RECREATIONAL VEHICLE SERVICE CAMPAIGN

Service Advisory: 18-332

SERVICE ADVISORY # 18-332

Coleman Water Heater Switch

Fig. 1

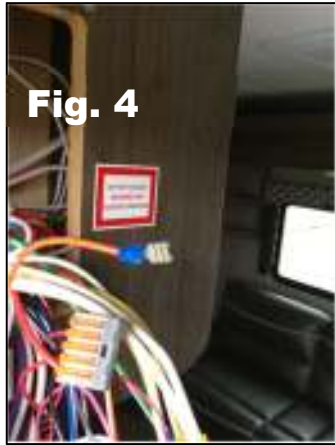
Locate and remove monitor panel near main entrance door, Figure 1.

Fig. 2

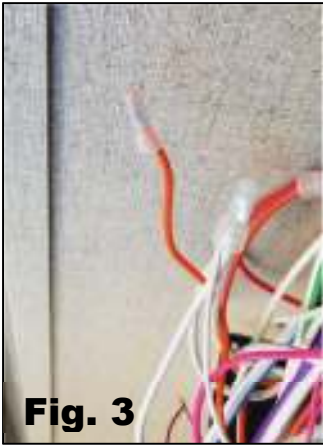
Remove switch plug in the W/H electric switch location, see Figure 2, and install the KRV # 115566 – Switch – Monitor Panel Small – Illuminated Red in its place with brass-colored blade at the top. See **Step 3** for wiring instructions.
